GUAM ENVIRONMENTAL PROTECTION AGENCY • *AHENSIAŃ PRUTEKSIÓN LINA'LA' GUÅHAN*
LOURDES A. LEON GUERRERO • GOVERNOR OF GUAM | JOSHUA F. TENORIO • LIEUTENANT GOVERNOR OF GUAM
WALTER S. LEON GUERRERO • ADMINISTRATOR | MICHELLE C. R. LASTIMOZA • DEPUTY ADMINISTRATOR

July 23, 2021

SUBJECT: Site Inspections at Samsung Mangilao Solar Project Site, July 23 and 18, 2021

Overall site plan, but note that the designs of Pond 3 (center bottom) and Pond 4 (right bottom) were changed, and a Pond 5 was added (upper annotated discharge location) w/ GEPA approval (see additional photos)

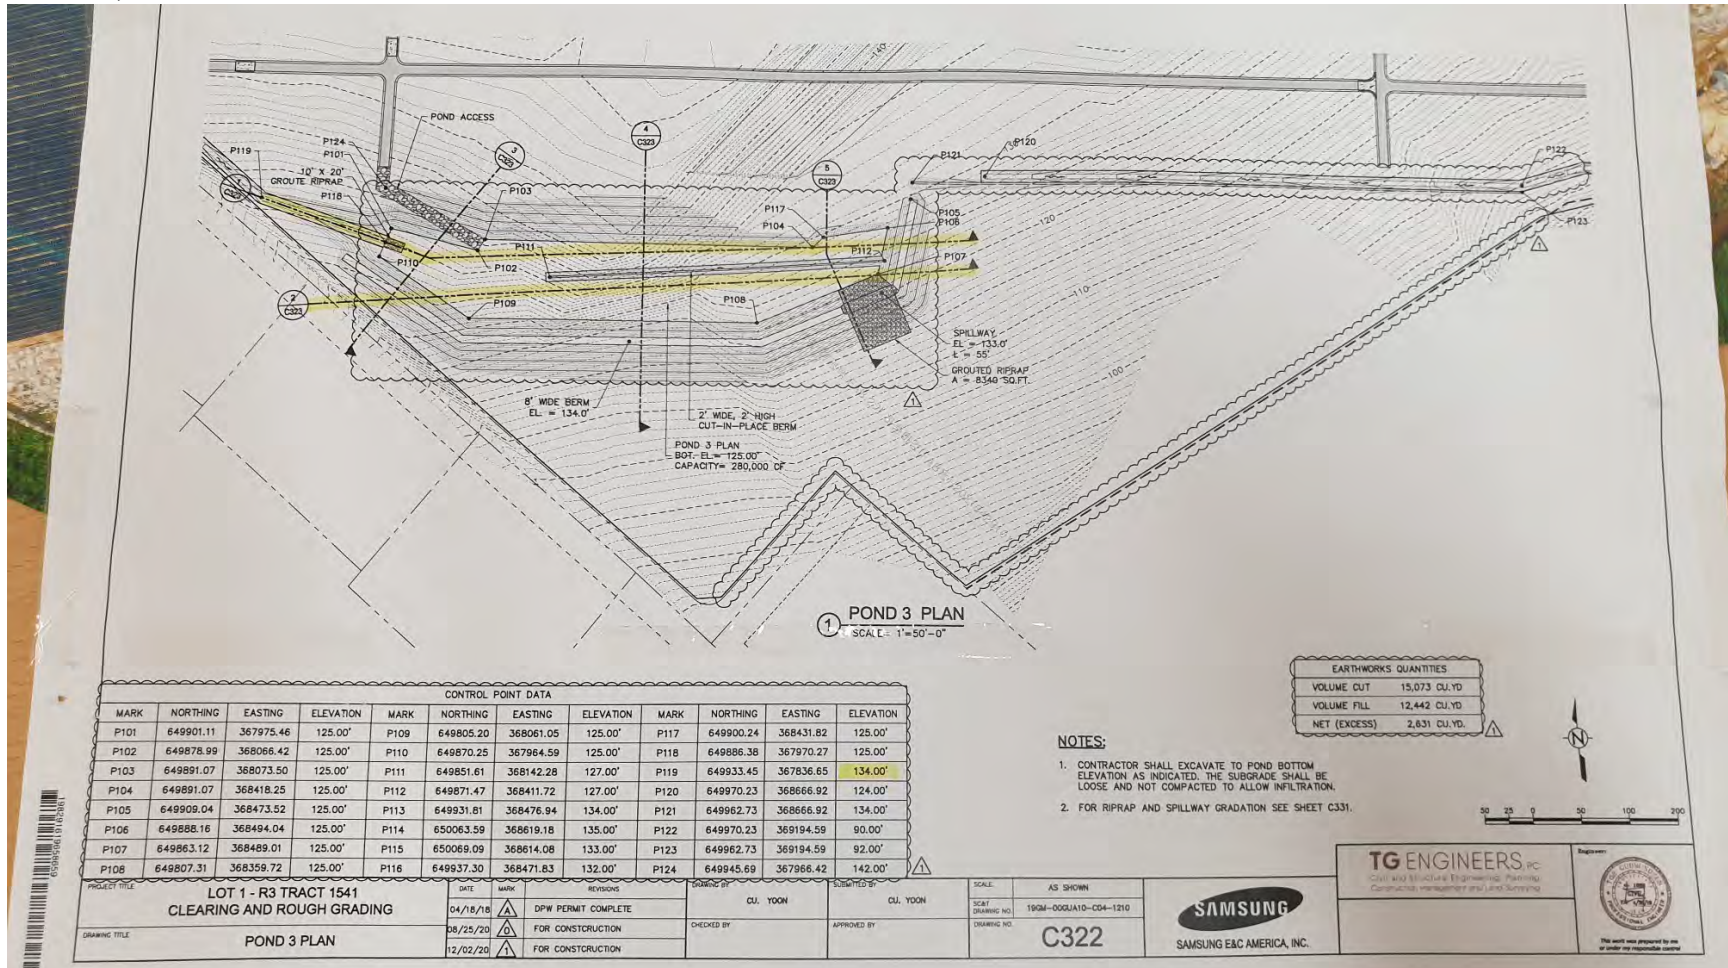
Annotations in red added to highlight location of discharges toward Marbo Cave (upper) and from Pond 4 area (lower), which was the subject of the complaint.

Site aerial image taken July 22, compared to approved E&SC plans (revised plan approved July 2020 in center), showing location of office at Pond 4 site (July 23, 2021)

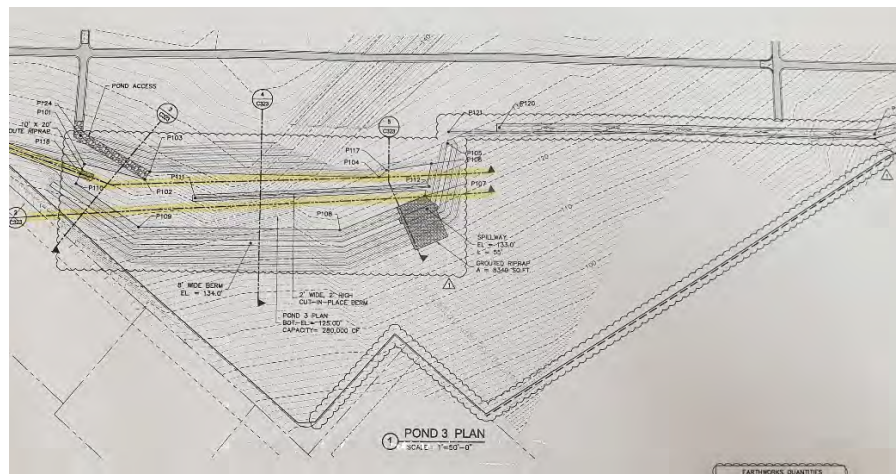
Aerial photo dated July 22, 2021 at location of Pond compared to approved E&SC plan (July 23, 2021)

ADDENDUM: Inspection of Pond 5, July 28, 2021. Excerpt from revised E&SC plans approved by GEPA January 4, 2021, adding Pond 5 to the area which would discharge toward Marbo Cave:

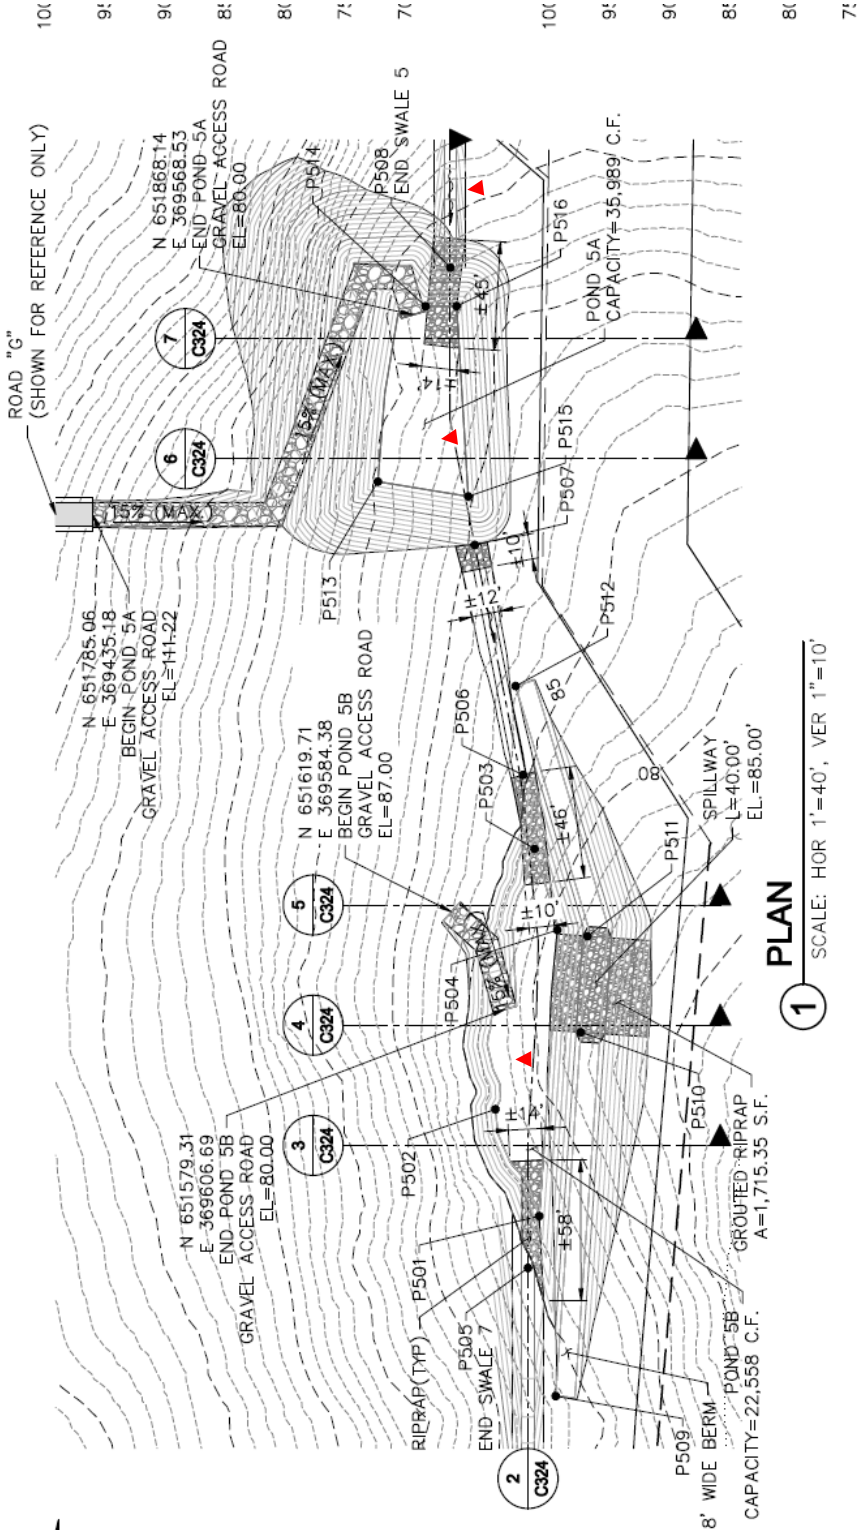
Perimeter swale shown in photos

Pond 5A

Pond 5B
